HISTORIC AND DESIGN REVIEW COMMISSION

March 06, 2019

HDRC CASE NO: 2019-100
ADDRESS: 306 E PARK AVE
310 E PARK AVE
LEGAL DESCRIPTION: NCB 392 BLK 30 LOT 2 & S 17.71 FT OF 1
NCB 392 BLK 30 LOT 3&4
ZONING: IDZ, IDZ,H
CITY COUNCIL DIST.: 1
DISTRICT: Tobin Hill Historic District
APPLICANT: Patrick Christensen
OWNER: Imagine Built Homes LLC
TYPE OF WORK: Construction of ten townhomes
APPLICATION RECEIVED: February 11, 2019
60-DAY REVIEW: April 16, 2019
REQUEST:

The applicant is requesting a Certificate of Appropriateness for approval to construct ten single family townhomes on the vacant lots addressed 306 and 310 E Park Ave. Two of the townhomes will be 2-stories and the remaining eight will be 3-stories.

Mc CULLOUGH
WEST ELEVATON

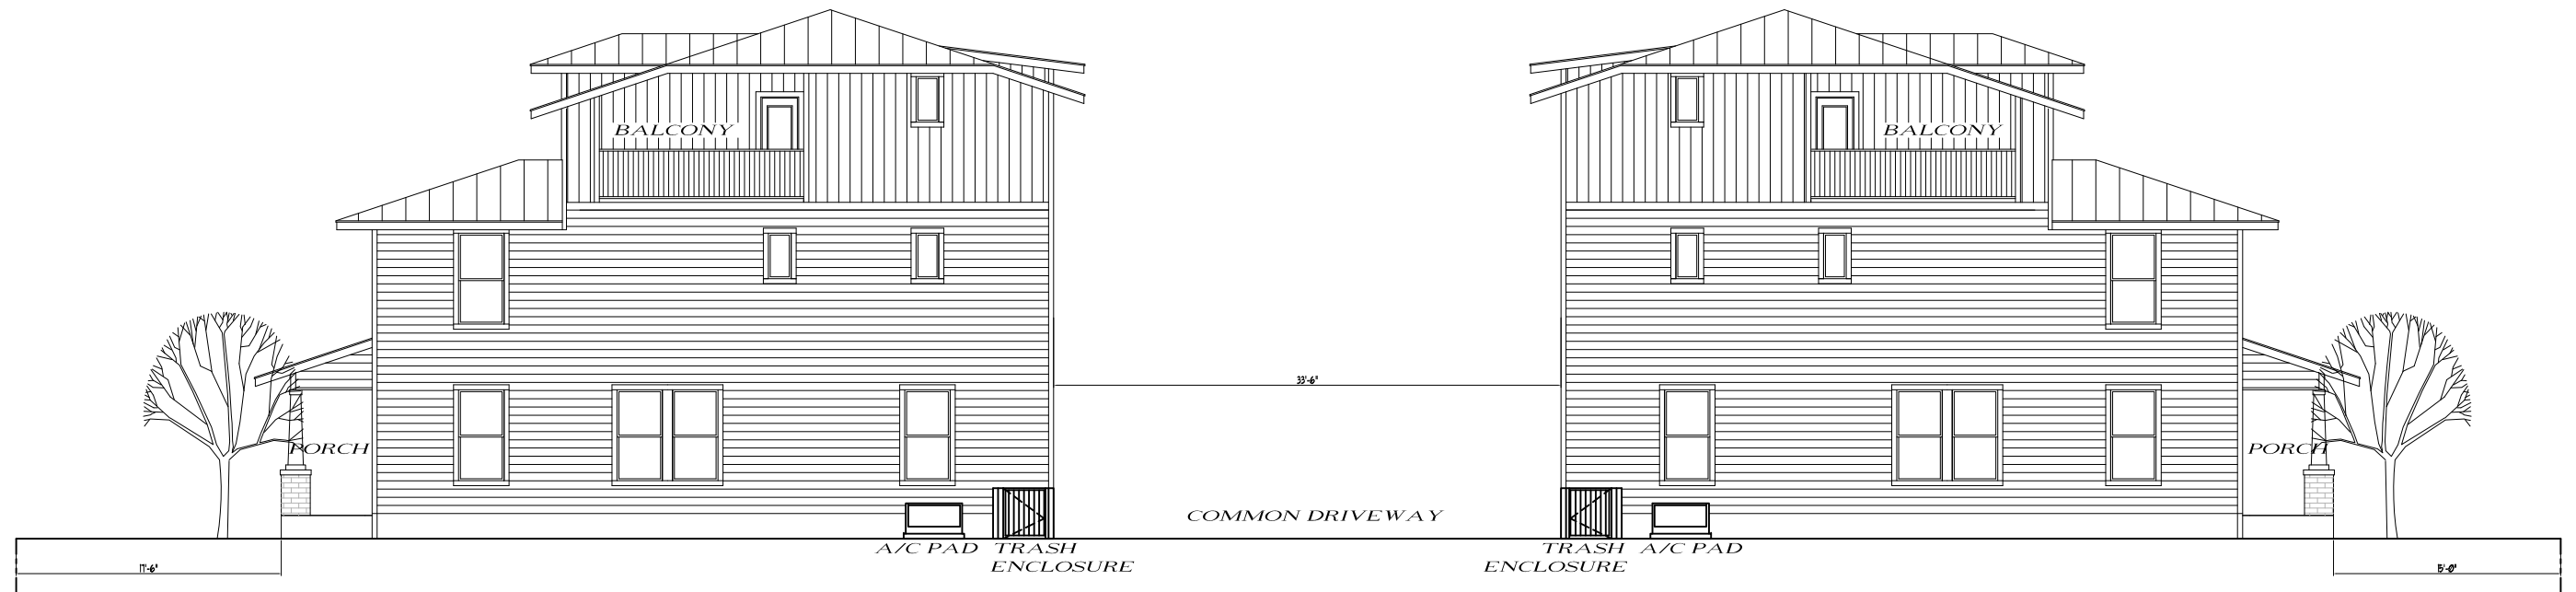
- g. SCALE & MASS – The applicant has proposed ten detached units within the district. Eight are three stories in height and the two closest to the street on E Park are two stories in height. The submitted elevations do not indicate a ridge height for any structure. Guideline 2.A.i stipulates that the height and scale of new construction should be consistent with nearby historic buildings and should not exceed that of the majority of historic buildings by more than one-story. Staff finds that the overall height should be lowered to be more consistent with the Guidelines. Additionally, staff finds that the front two buildings facing Park Ave feature a façade width that is uncommon in the Tobin Hill Historic District. The proposed structures are wider than the adjacent two story historic houses on the block, which also feature full width front porches, generally symmetrical facades, and a consistent relationship of solids to voids. Staff finds that the massing of the front units should be modified to be more consistent with the Guidelines and the historic precedents on the block.

- i. ROOF FORM – The applicant has proposed a hipped roof form. Staff finds that the general approach is consistent with the historic precedents in the district, particularly the proposed 2-story structures. However, staff finds that the hipped roof form of the second story for the 3-story structures is a departure from traditional patterns. Additionally, as noted in finding g, the overall height of the roof ridgelines should be reduced.

- k. WINDOW & DOOR OPENINGS – According to the Historic Design Guidelines for New Construction, window openings with a similar proportion of wall to window, as compared to nearby historic facades, should be incorporated. Similarity is defined by windows that are no larger than 25% in size and vary no more than 10% in height to width ratio from adjacent historic facades. The applicant has proposed several window and door openings that generally feature sizes that are found on historic structures. However, the applicant has also proposed window openings that are not consistent with the OHP Window Policy Document or historic fenestration precedents in the district, particularly small rectangular openings with no divided lites. According to the OHP Window Policy Document, wood windows are most appropriate. Windows should also maintain traditional dimensions and profiles, and false dividing lites are not encouraged. Each window should be inset at least two (2) inches within walls to ensure that a proper façade depth is maintained. All windows should feature traditional appearance and feature traditional trim and sill details.

- n. ARCHITECTURAL DETAILS – New buildings should be designed to reflect their time while representing the historic context of the district. Additionally, architectural details should be complementary in nature and should not detract from nearby historic structures. The proposed buildings feature design elements that are generally consistent with the Guidelines and are appropriate for the Tobin Hill Historic District. However, closely matching structures in a development are a deviation from the development pattern of the district. Staff finds that individualized elevations should be developed to be more consistent with the Guidelines.

- iv. That the applicant reduces the width of the two front buildings facing Park Ave and incorporates more consistent architectural features, including proportionate porch elements and a consistent solid to void relationship, to be more consistent with massing precedents in the district as noted in finding g.

- v. That the applicant develops individualized street elevations for each unit to be more consistent with the development pattern of the district as noted in finding n.

- vi. The applicant explores 1.5 to 2.5-story massing options or prototypes within the district boundary to respond to the dominant historic massing context of the historic neighborhood.

PLOT PLAN

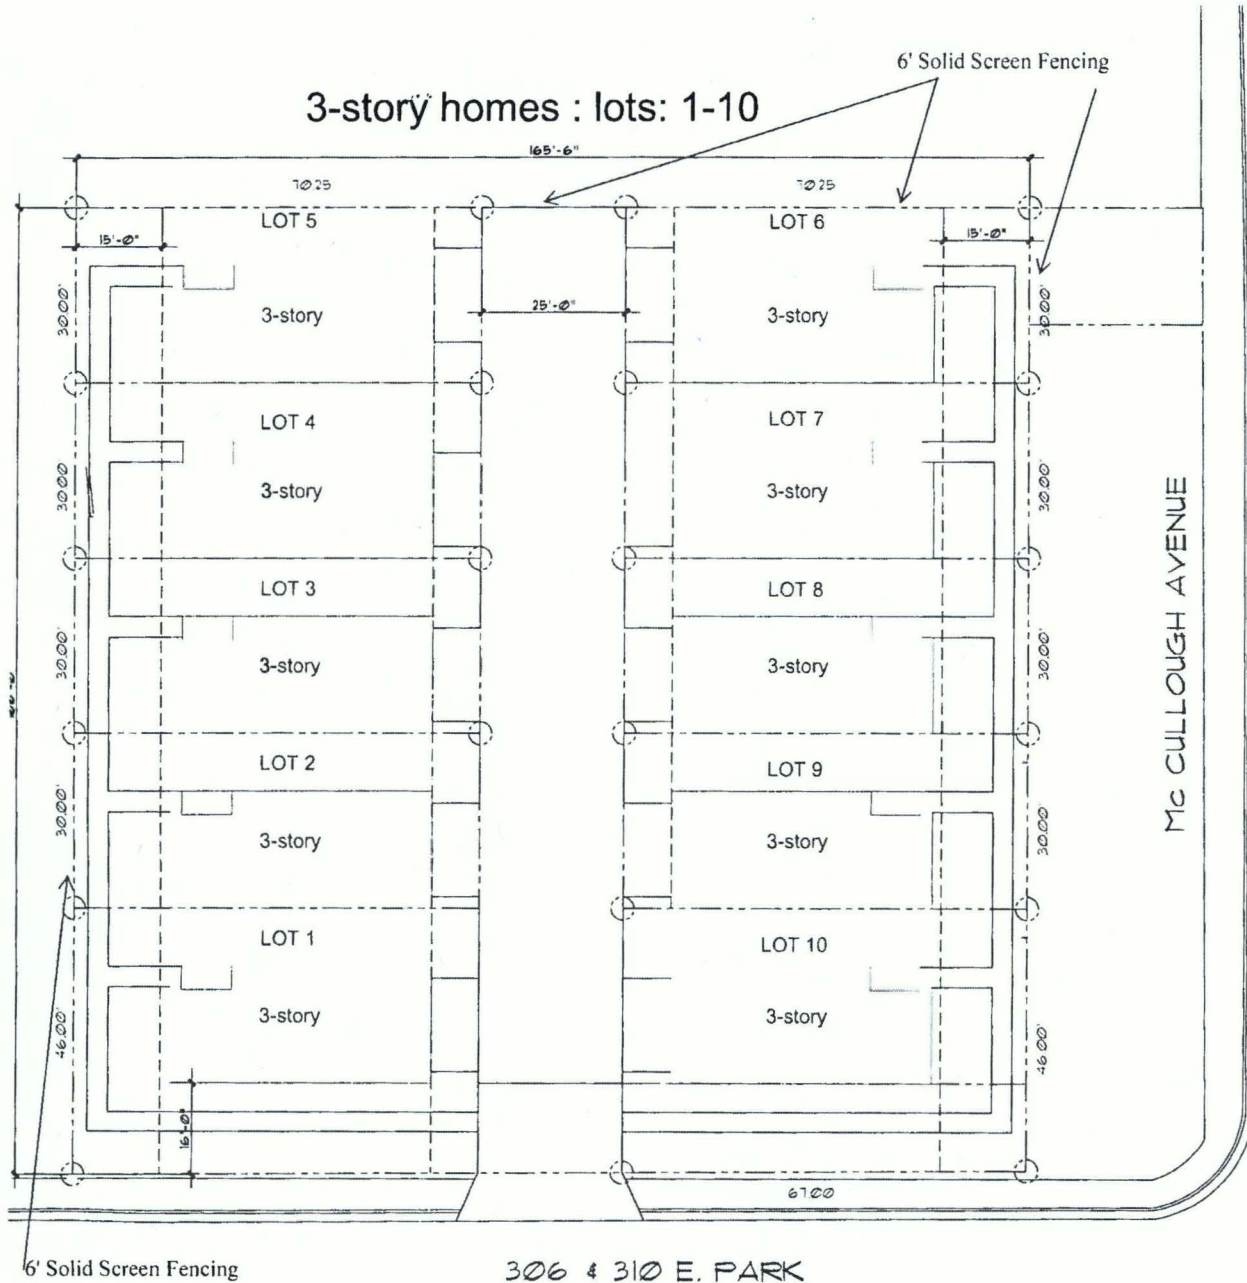
- d. CONTEXT AND DEVELOPMENT PATTERN – As presented, the individual units reviewed as standalone structures exhibit some features that are generally consistent with the overall principles in the Guidelines. However, when considering the proposed streetscape and context of the project, the proposed design does not relate well to the historic single-family residential nature of the district and the district's predominant developmental pattern. Several components of the design, including the height, setbacks, porch configuration, footprint, and fenestration, are not familiar in terms of the predominant development pattern. In particular, the submitted site plan deviates substantially from the development pattern of the Tobin Hill Historic District, which is commonly characterized by a primary-accessory structure relationship with a side driveway.

- e. SETBACKS – According to the Guidelines for New Construction, the front facades of new buildings are to align with front facades of adjacent buildings where a consistent setback has been established along the street frontage. The median setback should be used where a variety of historic setbacks exist. This block of E Park contains historic structures that feature a fairly consistent front yard setback of approximately 33-34 feet from the street curb. The applicant has proposed approximately a 25 foot setback from the street curb. Staff finds the proposed setbacks inconsistent with the Guidelines.

- f. ORIENTATION & ENTRANCES – The applicant has proposed to orient the two units fronting E Park Ave towards the street. The other eight units will be oriented either towards McCullough Ave or towards the neighboring structure to the east. All units will provide vehicular access from a common drive in the middle of the site. According to the Guidelines for New Construction, the front façade should be oriented to be consistent with those historically found along the street frontage. Typically, historic entrances are oriented towards the primary street. This is true for this particular block of E Park Ave. Staff finds the orientation and entrances of the proposal to be departure from typical development patterns in the vicinity. Additionally, although four of the structures are facing west towards McCullough, a separately-owned vacant lot is located between this proposed development and McCullough. While the lot is currently vacant, the four structures facing this direction may face the rear of a structure in the future, which deviates from the historic development pattern. Staff finds that a primary and secondary relationship would be most consistent with the Guidelines. Staff also finds that an interior courtyard condition would be more appropriate than the current proposal.

- q. HARDSCAPING – The applicant has proposed a 33'-4" wide central driveway property accessible off E Park. The Guidelines state that driveway should be a maximum of 10 feet to comply with the historic development patterns of the district. Staff finds that the proposed parking pattern with a shared central drive deviates from the historic development pattern of the district, and finds that the proposed driveway width is inconsistent with the Guidelines.

- i. That the applicant explores ways to increase the setback on E Park Ave to be more consistent with the adjacent historic structures as noted in finding e.

- ii. That fewer buildings are explored to be more in keeping with the established development pattern within the district based on finding c.
- iii. That the applicant explores a primary-accessory structure relationship or interior court condition in lieu of the orientation of the rear 8 buildings as noted in finding f.

- ix. That the applicant reduces the central driveway width as noted in finding q.
